**Comments of Public Service Company of New Hampshire  
on EPA's Draft National Pollutant Discharge Elimination  
System Permit No. NH 0001473 for Schiller Station**

**Comments of Public Service Company  
of New Hampshire  
(d/b/a Eversource Energy)**

**Permit No. NH0001473**

**Schiller Station**

Figure 2-1: Example illustrating the decline in abundance of Winter Flounder life stages from spawning to adulthood based on published life history parameters<sup>3</sup>.

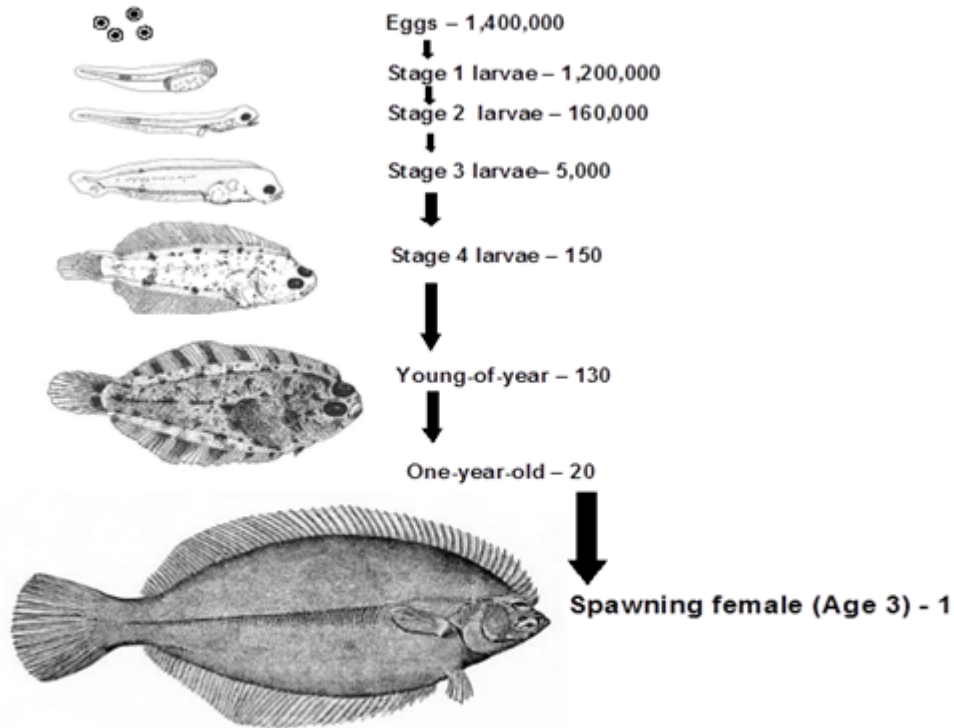
Figure 2-1 in the 2016 Enercon-Normandeau Comments depicts the survivorship curve of the Winter Flounder and puts the above-referenced comments in proper context by demonstrating

that a miniscule number of eggs and larvae of organisms subject to entrainment at Schiller Station would survive to adulthood even in the absence of the facility’s CWISs:

Only one out of 1.4 million Winter Flounder eggs is likely to survive in waters similar to the Piscataqua River to become a three-year-old spawning fish—one.<sup>118</sup> Moreover, nearly 99 percent of the eggs die of natural causes within 60 days following spawning. Remarkably, fecundities of other abundant fish and macrocrustacean taxa typically entrained by CWISs at Schiller Station are roughly equivalent to the Winter Flounder and/or are comparatively higher than the median taxa. Furthermore, like the Winter Flounder, early life stages of these other abundant fish and macrocrustacean taxa typically entrained by the facility’s CWISs also

Figure 4-1: Plot of cumulative AIF in MGD (Ref. 7.6)

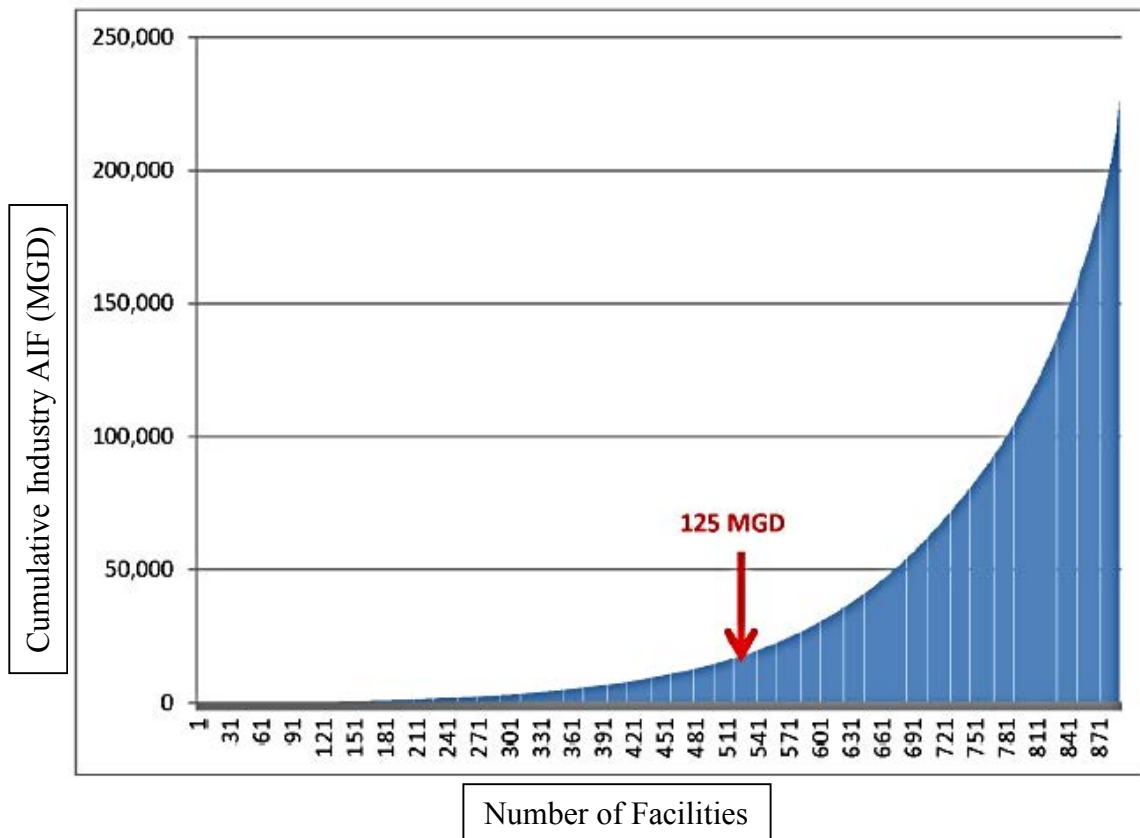
The figure of interest (Figure 4-1) is provided below. This figure shows that the vast majority of water used by existing facilities in the United States is withdrawn by the biggest users. The horizontal axis shows a listing in facilities in increasing order, and the cumulative AIF (total water withdrawn by all facilities up to that point) is displayed on the vertical axis.

Therefore, EPA appears to have concluded that the 125 MGD AIF threshold for submittal of entrainment-related information was a policy decision to achieve the greatest nationwide entrainment reduction at the lowest cost to the industry. By this logic, EPA focuses on the largest users of water and limits the burden on smaller facilities.

Figure 4-3: Existing facilities and flow addressed by various flow thresholds (Ref. 7.6)

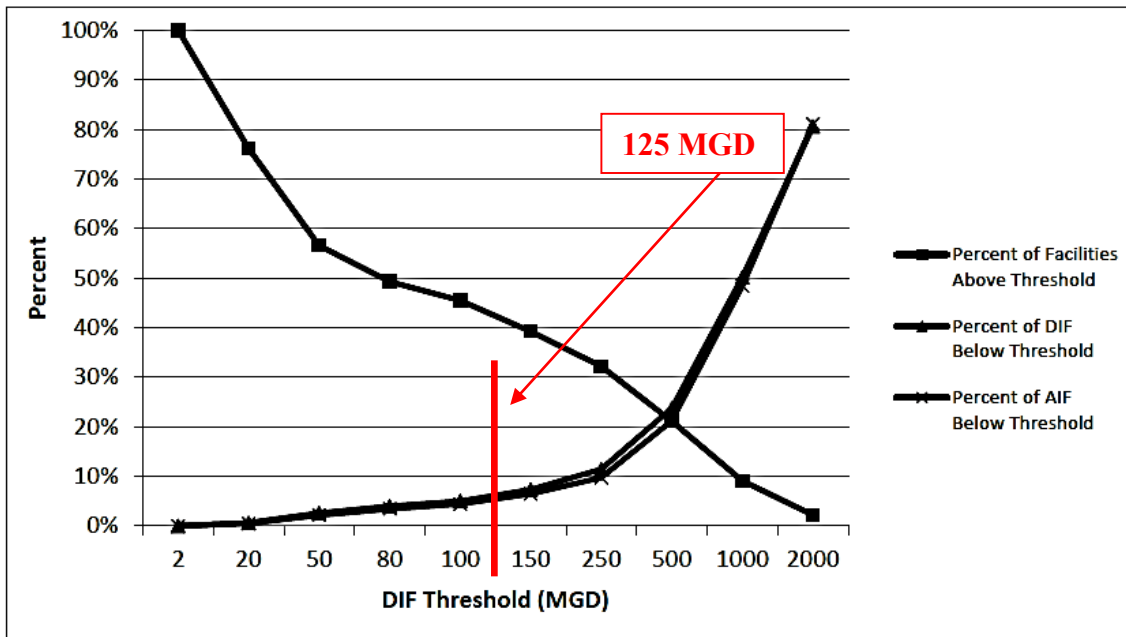
Finally, Exhibit 5-15 in EPA’s Technical Development Document (Ref. 7.6) shows the percentage of existing facilities that would be encompassed by various DIF thresholds for required entrainment compliance evaluation. The industry data in general shows little difference between AIF and DIF, even though AIF is slightly more than half the DIF at the Station. The upper line in Figure 4-3 shows the percentage of facilities that would be required to supply entrainment information under the Rule for various flow thresholds. Additionally, the bottom lines in Figure 4-3 show the percentage of total cumulative AIF/DIF that would be exempt from (not subject to) said threshold. Presumably, Exhibit 5-15 as shown in Figure 4-3 was used by EPA to determine an appropriate cut-off for facilities that are required to submit the additional entrainment-related information required by the Rule to aid in determination of a site-specific BTA for entrainment.

Figure 4-3 illustrates that approximately 42 percent (from visual inspection) of facilities considered by EPA would be subject to the information requirements of a 125 MGD DIF threshold. Additionally, Figure 4-3 also illustrates that such a threshold would capture all but approximately 6 – 7 percent (from visual inspection) of the total industry AIF and DIF. Put differently, such a threshold would capture 93 – 94 percent of all industry AIF and DIF. From Figure 4-3, it appears that EPA’s logic to establish a 125 MGD AIF threshold is to encourage facilities to utilize operational measures to reduce intake flow (Reference 7.6). The 125 MGD threshold represents a policy decision by EPA to produce the greatest entrainment reduction in a way that affects less than half of the industry.
